MEMORANDUM

RE: **Dunes Club, Healy, and Barry Properties
CRMC Wall Maintenance Comments
Narragansett, RI
Pare Project No. 25115.00**

R. Lucia's 09-18-2025
Email pgs 5 & 6

SECTION C - PROPOSED SEAWALL PROTECTION
SCALE: 1/2" = 1'-0"

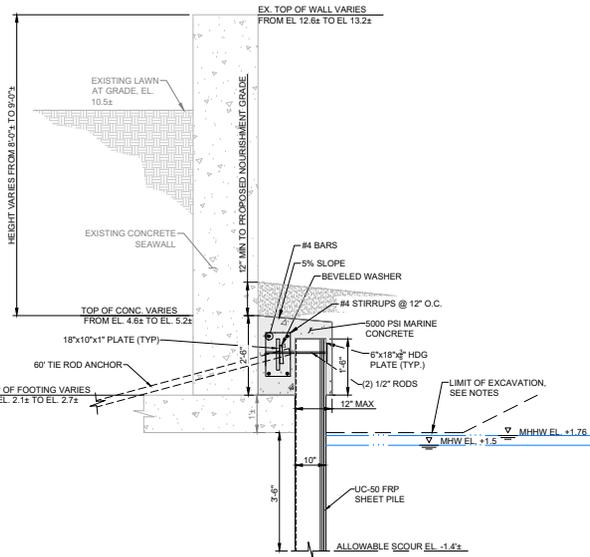
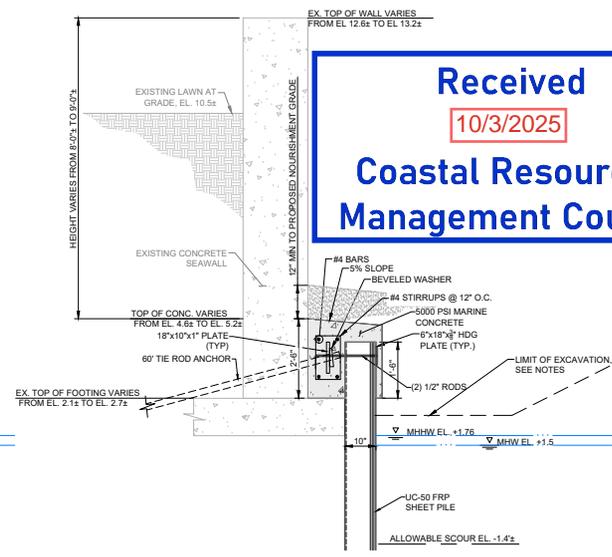
- *Comment/Question: at Berg property there was a toe repair performed with a larger footing and sheetpiles at "Section C", this is not shown on the plans, please clarify. For clarity lets call it the "Ernie George Plan" henceforth.*

Response: Section C has been updated and is attached for submission. It should be noted that the larger footing was not found during the test pit excavation conducted by NDW/Reagan, and it is uncertain whether it was installed as permitted for the entire length.

SECTION A - PROPOSED SEAWALL PROTECTION
SCALE: 1" = 1'-0"

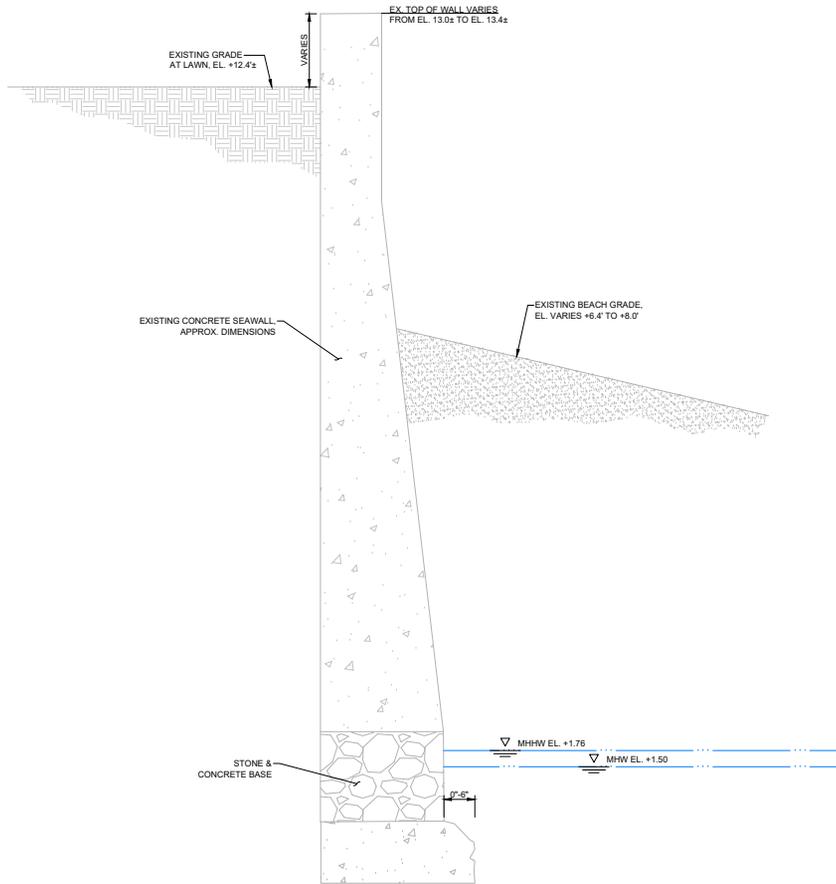
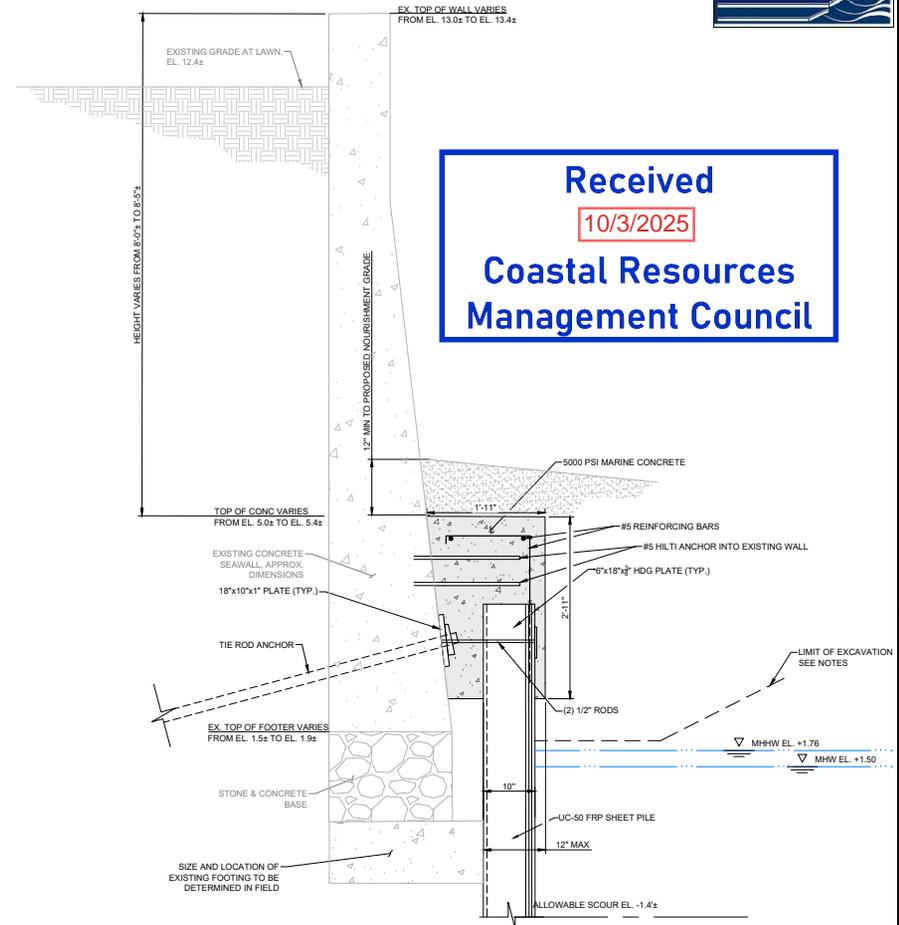
- *Comment/Question: Dunes Club shows a 3'-6" footing. (Does this have the Ernie George Plan" footing with sheetpile scour protection).*

Response: No, this does not have the "Ernie George Plan footing" this is the footing from the original wall repair. The bottom of the footing was previously exposed and was confirmed from the test pit exaction performed by NDW/Reagan.

SECTION A - PROPOSED SEAWALL TOE PROTECTION SYSTEM SECTION
SCALE: 1/2" = 1'-0"

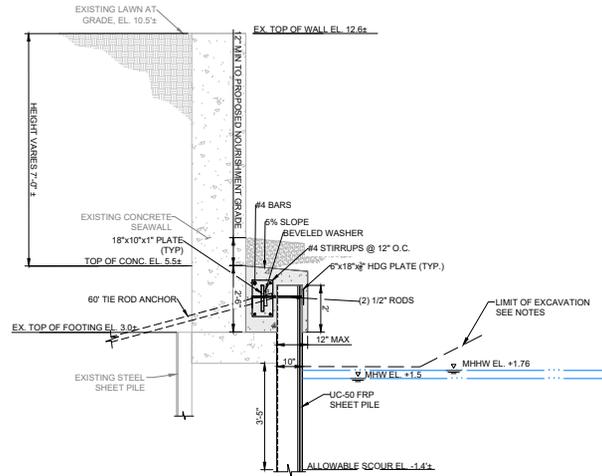
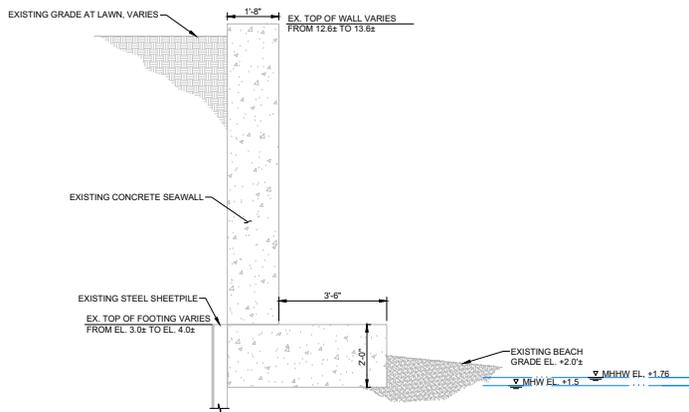
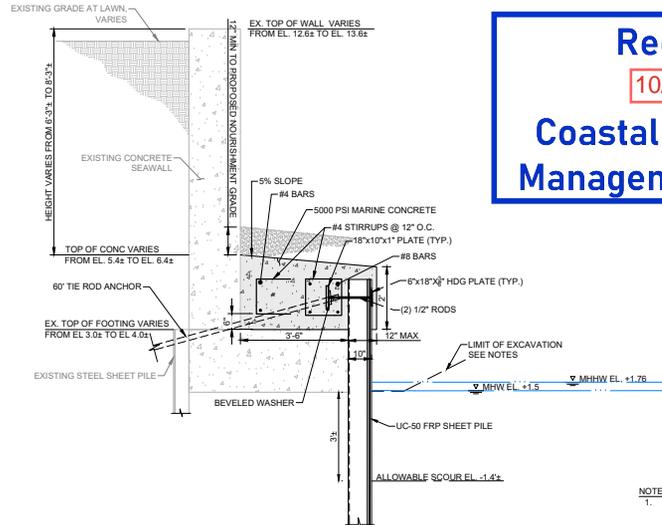
- *Comment/Question: At Healey property there was an Assent to build the "Ernie George Plan". The submitted cross section do not show this, the existing footing would be larger than shown on submitted plans. Is this footing going to be reconfigured like Bergs?*

- *Comment/Question: Before I put these projects out to notice, all the plans need to show the accurate footing elevations (existing and proposed) as well as the new clearance height of wall above the new footing (e.g. distance from top of footing to top of wall). Also, the seaward extent of the existing and proposed footing of Healy project.*

Response: During the test pit excavation, the repair found on this property was a flow fill under the wall, not the same repair as the Barry (Berg) property; therefore, the plans indicated that the footing extents will be confirmed during the installation and will need to be removed/adjusted accordingly. As-builts of the repair were not available to Pare.

Response: Cross sections have been updated to provide additional information requested.

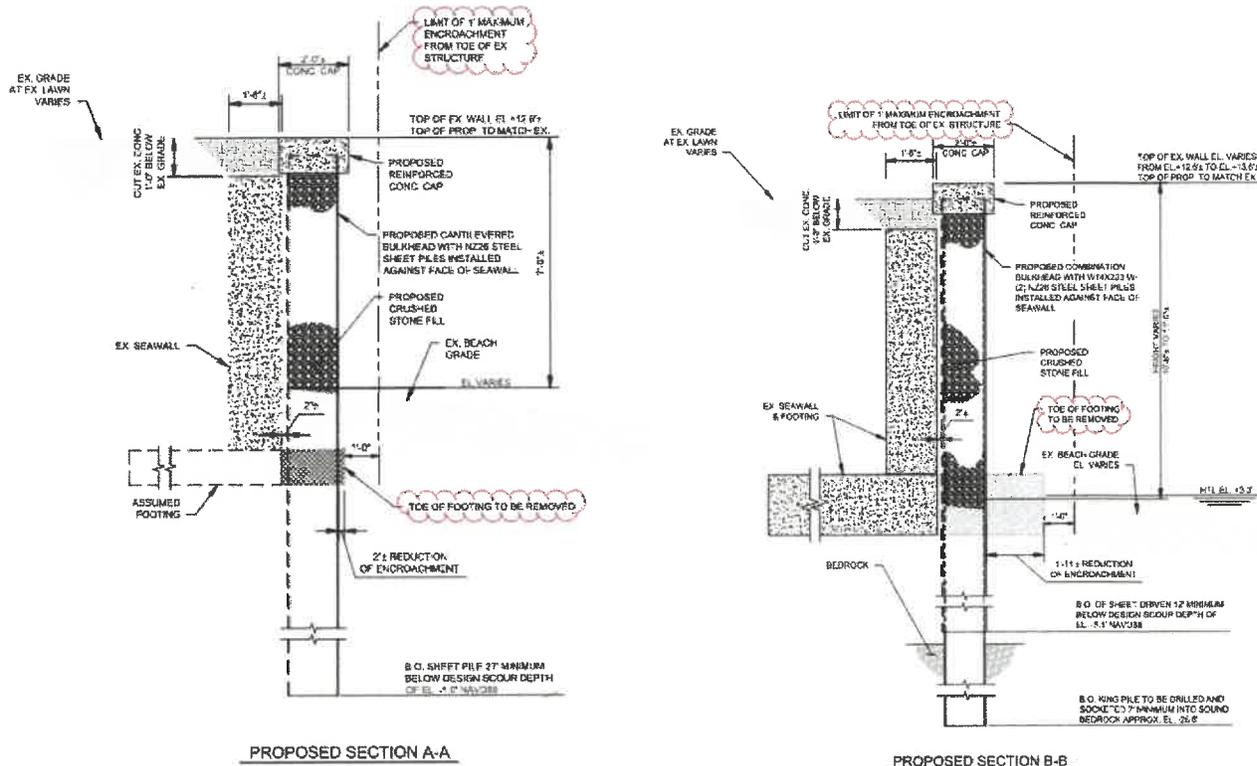
As submitted the wall will extend (Cross Section D-D) 20.32" seaward (3" (start of sheetpile) + 17.32" (height of NZ26)). The design will need to be revised in order to meet the 12" requirement. Cross Section E-E has the same issue, the wall will sheetpile, this will extend 20.32" (3" + 17.32" height of NZ26).

Additionally, regarding the depth of sheetpile (NZ26), please give the design depth of scour on plans.

The proposed repair option has been chosen after careful consideration of the other alternatives specifically so that it will meet the standards for Maintenance and Repair of shoreline protection. The construction sequence discussed above and shown on the proposed cross-sections demonstrate this. It is our opinion that the design as shown does not need to be revised as it meets the 12" requirement.

The design scour depth is based on USACE recommended methodology. For this project the scour depth is -1' NAVD88 and the sheets shall extend 27' below that elevation in one location and -5.1 NAVD88 in the other location with the sheets a minimum of 12' below. This is also detailed on the proposed repair plans in the application.

TEMPORARY ACCESS PLAN

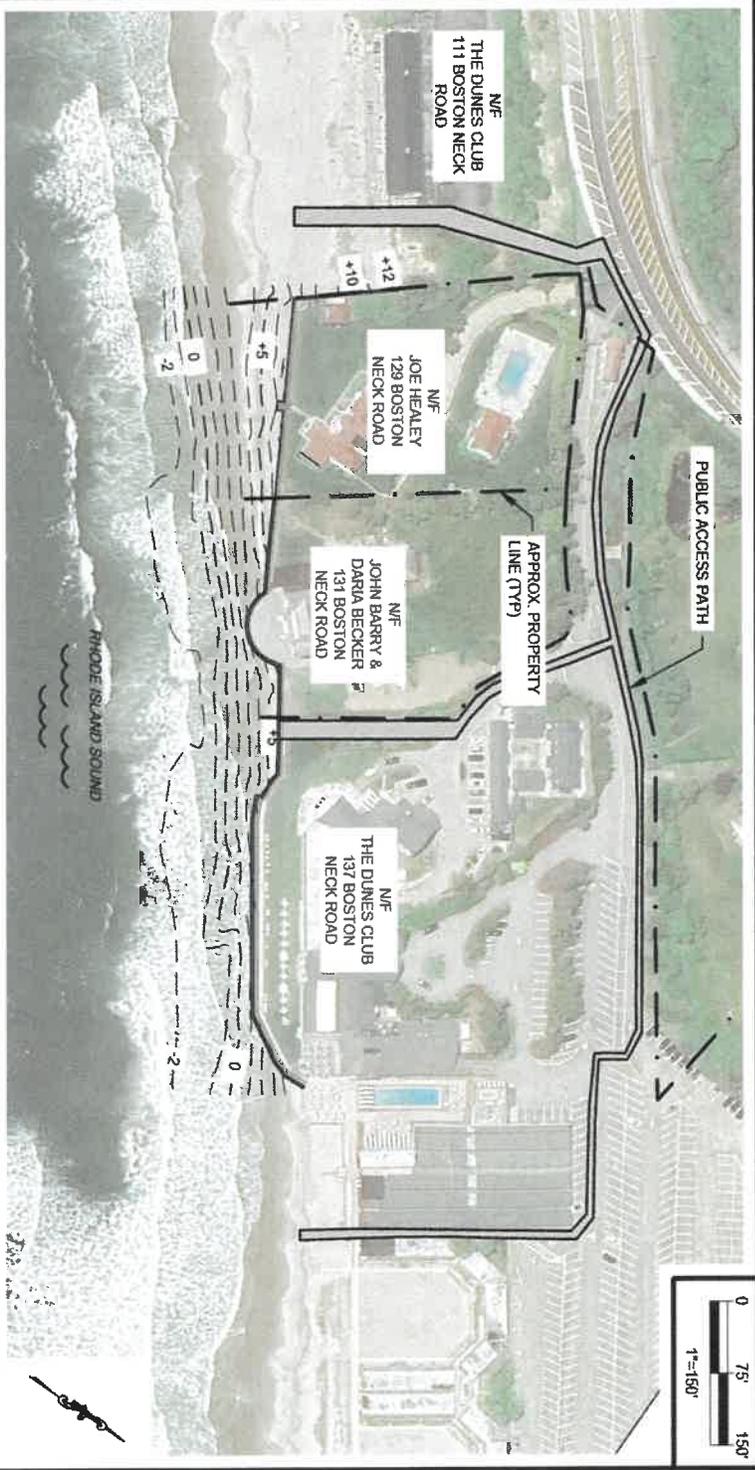
Lateral shoreline access may be negatively impacted by the proposed work. Applicant shall need to submit a plan which mitigates the negative impacts to lateral public access as part of this application.

The public access plan will need to provide long-term maintenance of the proposed access pathway/route.

Please see the public access plan included in the drawing set.

No permanent impacts to public access are anticipated as part of this project. Access will remain as currently existing once the project is complete, limited during high water events and unrestricted during low water events.
